ANACORTES PLANNING COMMISSION

1. **Roll Call**
2. **Minutes of January 22, 2020**
3. **Correspondence**
4. **New Business**
Pre-Decision Open Public Hearing: Conditional Use Permit - CUP 2019-0002 - to allow expansion of the Grandview Cemetery at 411 Hillcrest Drive.

Project Title	Grandview Cemetery Expansion	Date of Report	March 5, 2020
File Number	CUP-2019-0002 & SEPA Review	Attachment	Site & Landscape Plans
Administrative Recommendation	Approve the site plan subject to the conditions of approval contained in Section B.

Sheet ID: S2

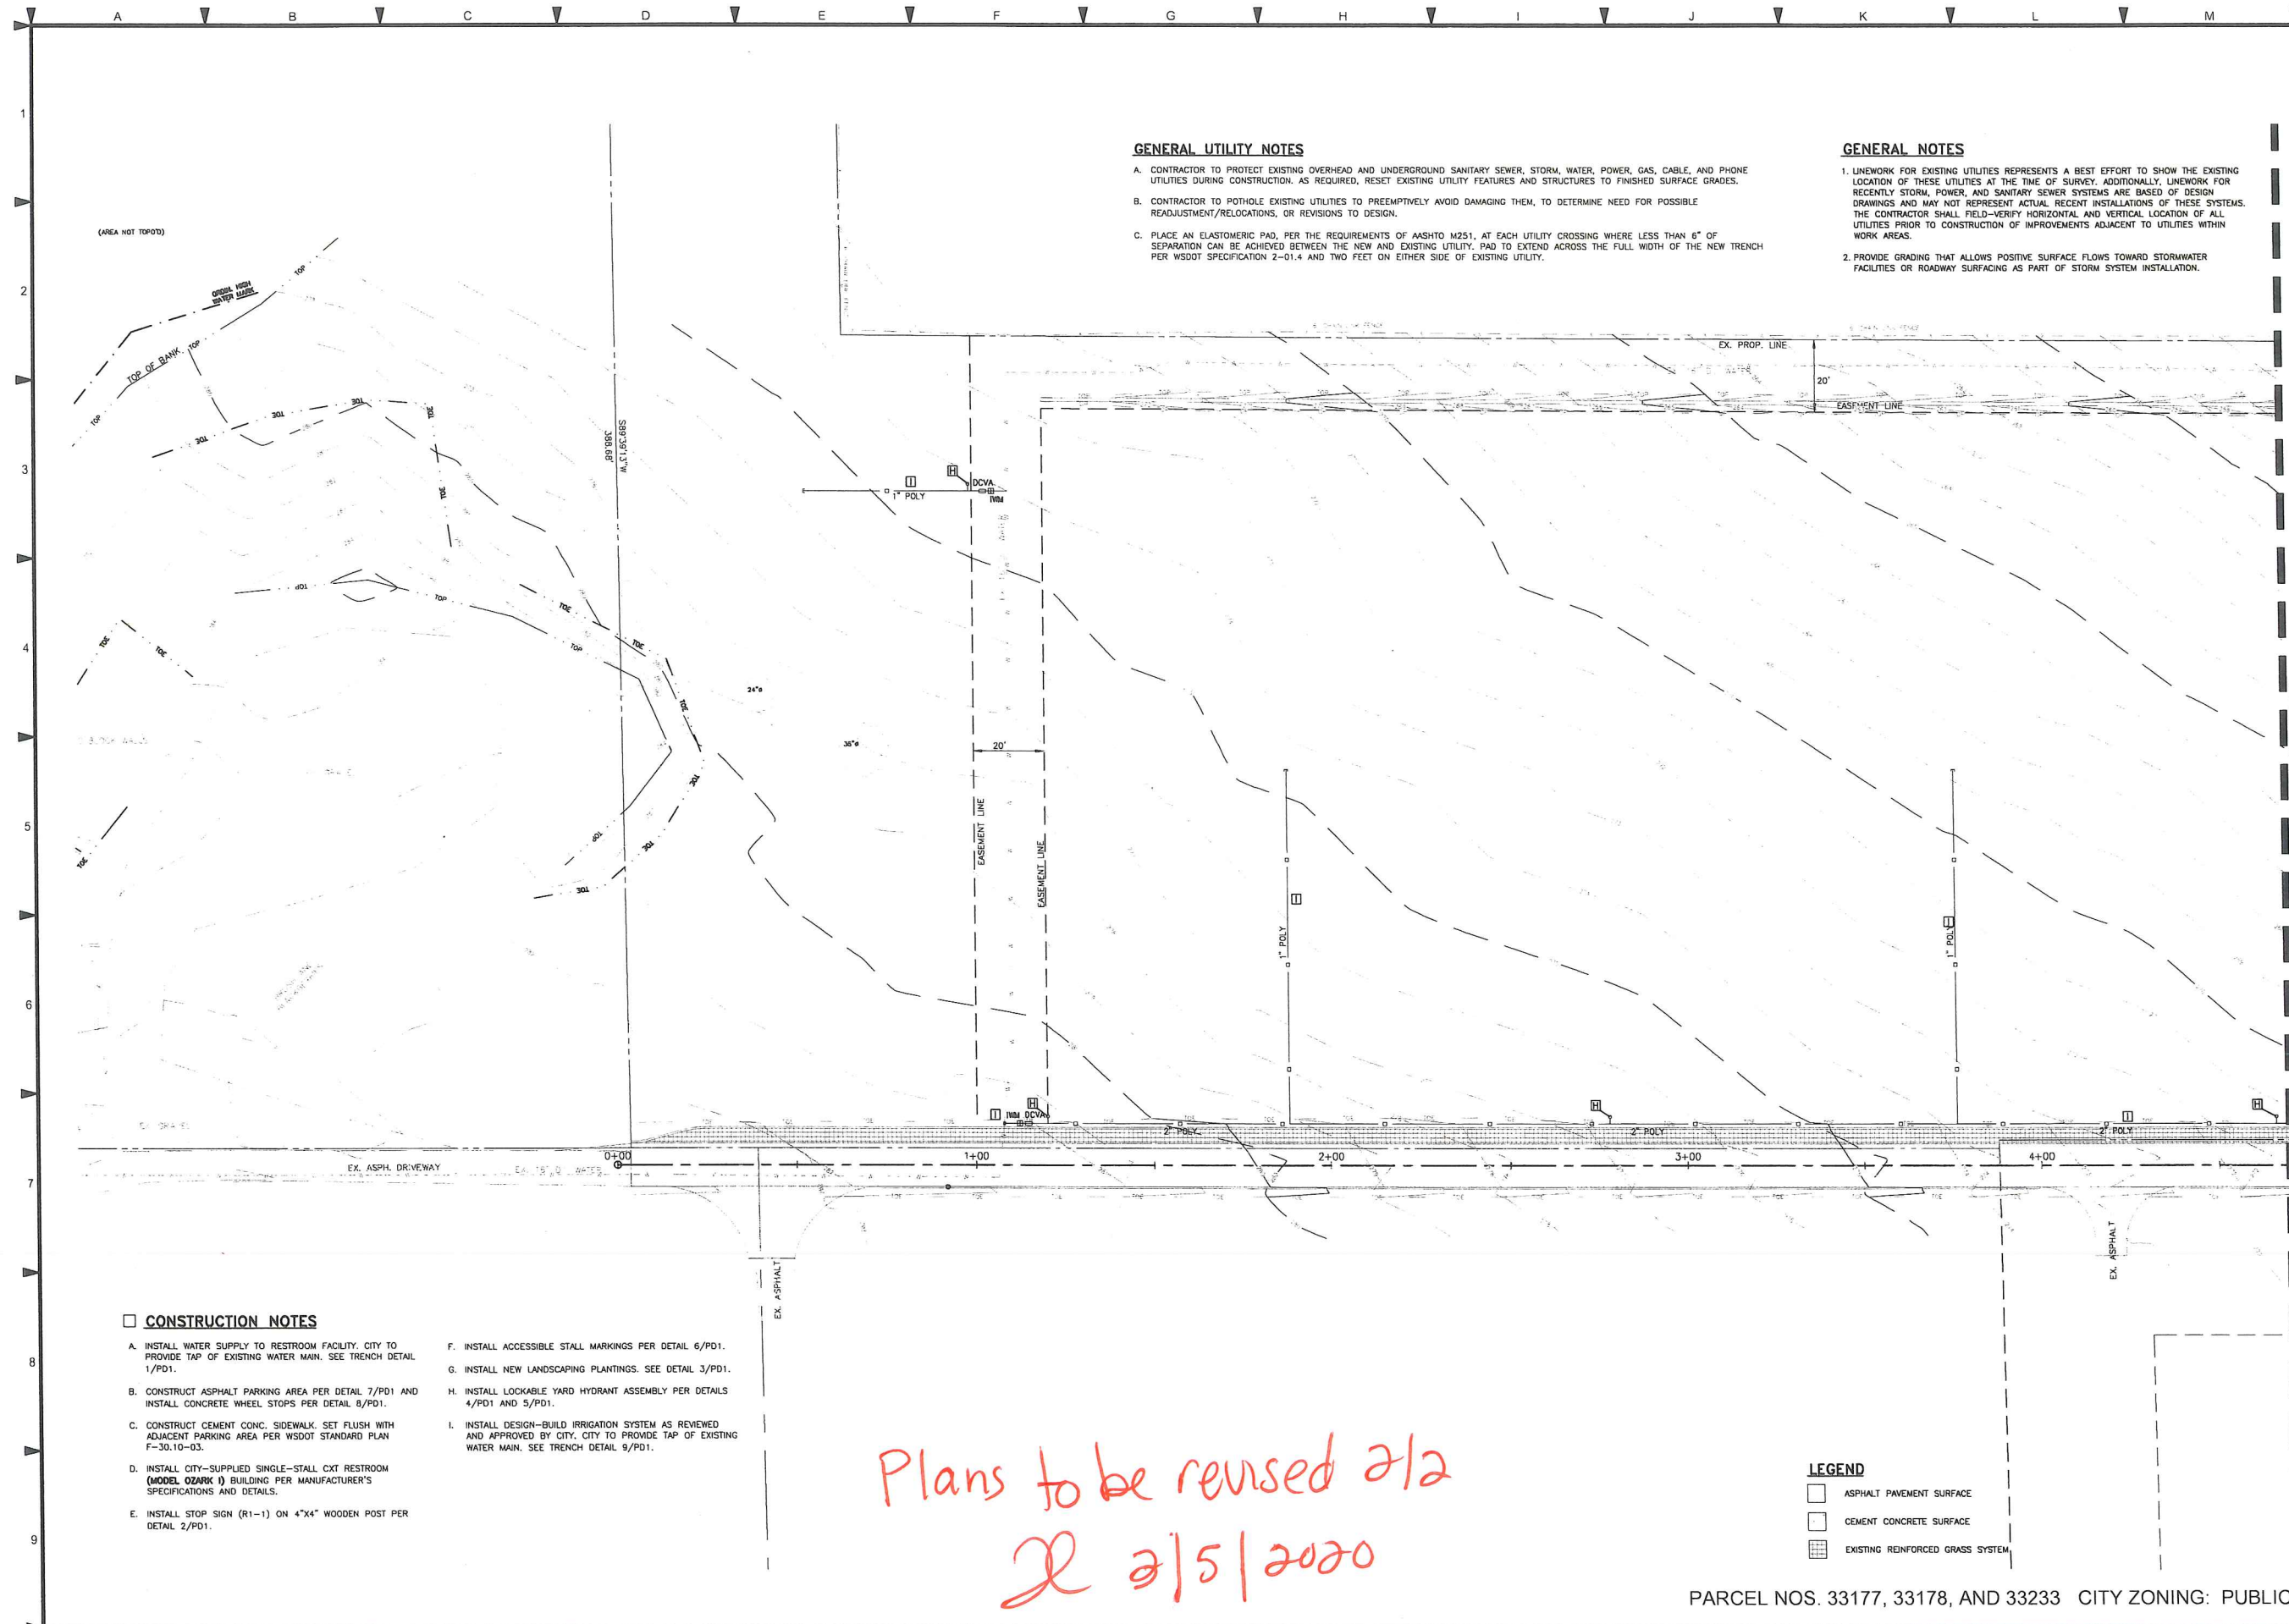
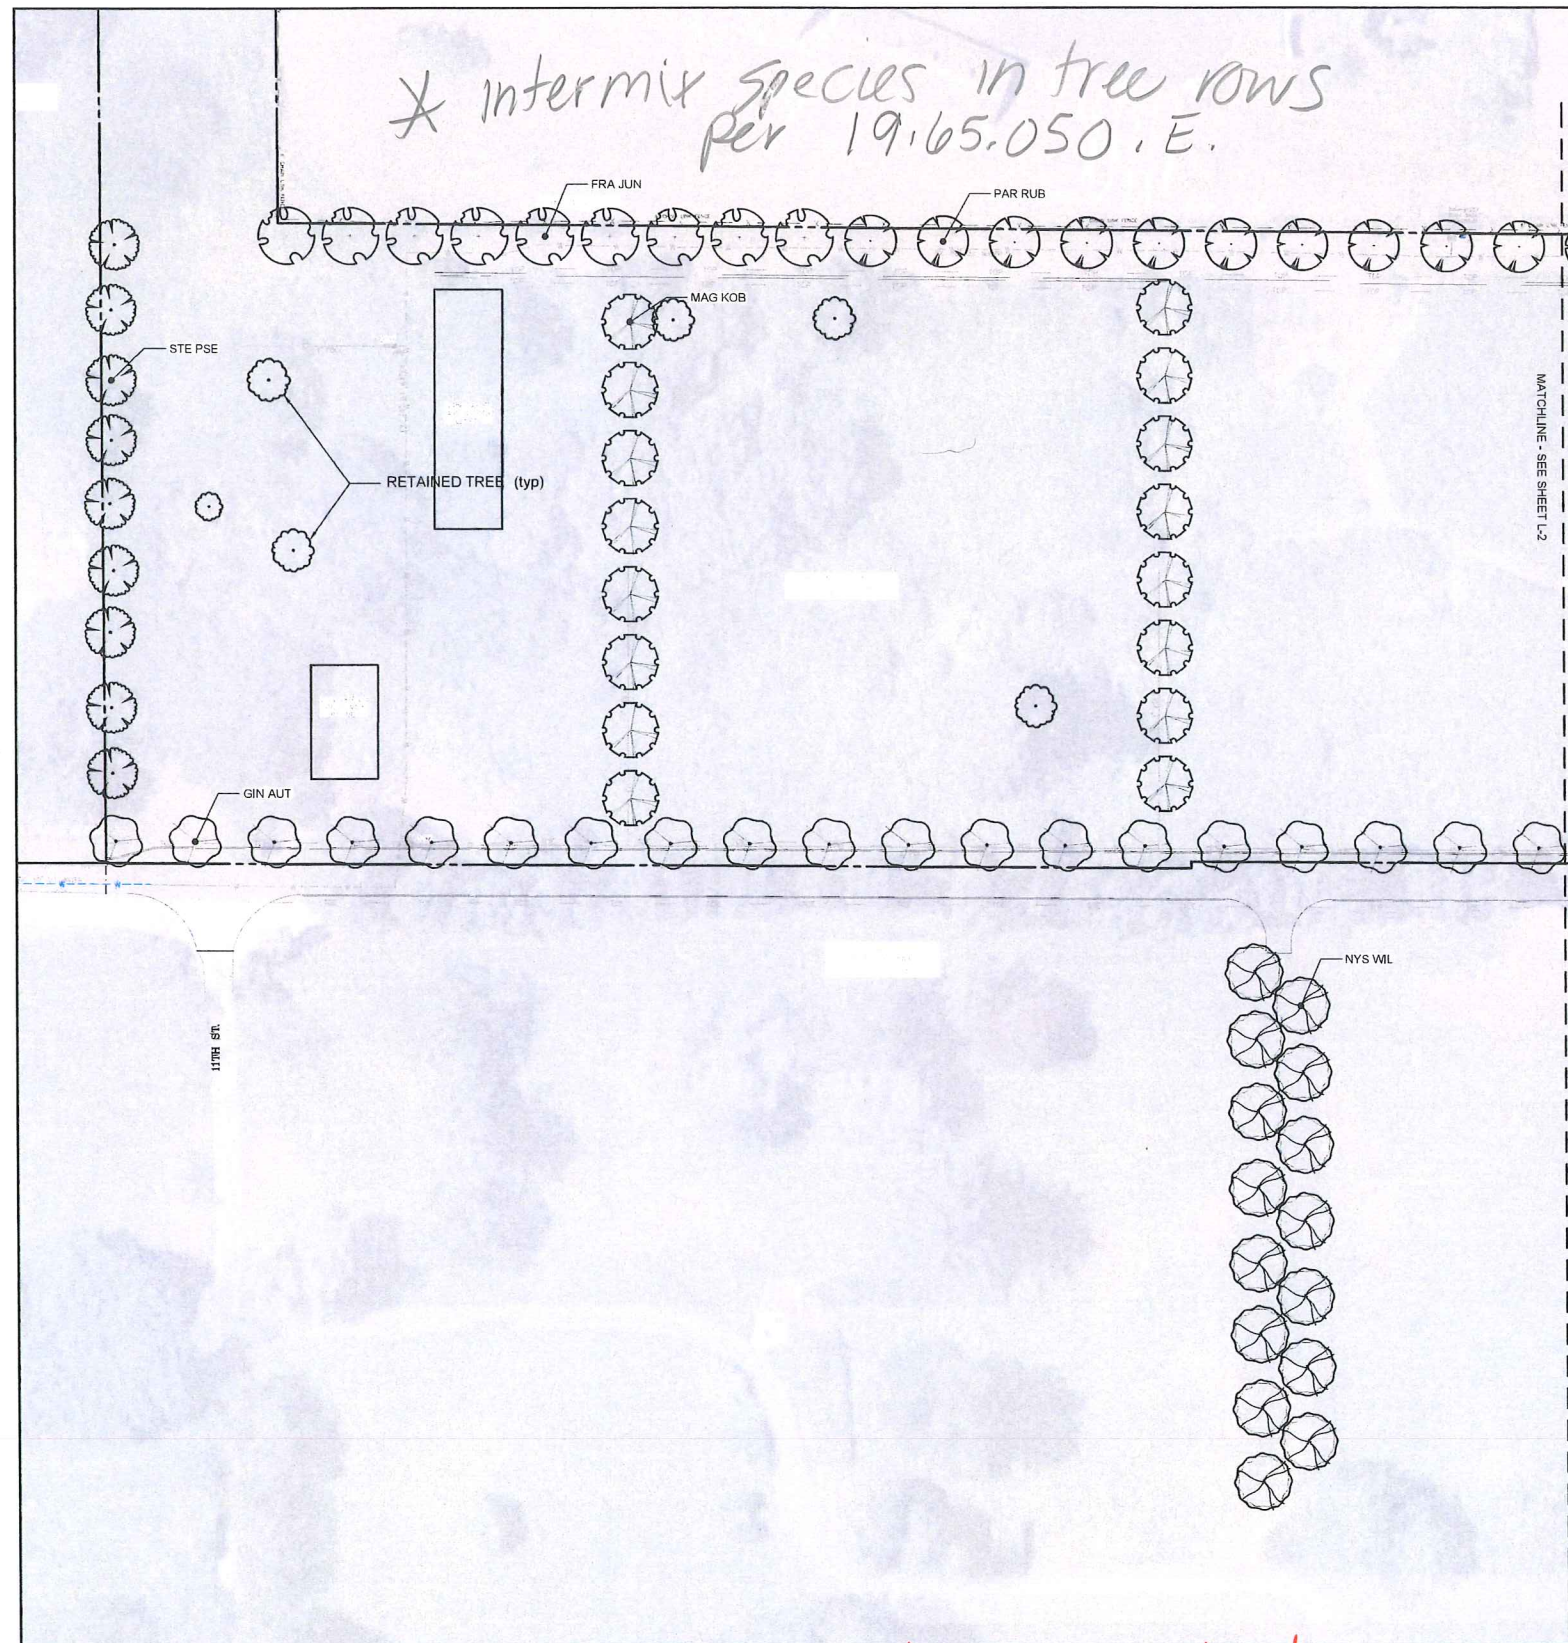
2. A new landscape plan to be submitted prior to construction that reflects the requested changes and redlines on the plan sheets dated 10-31-19 (see exhibit H).
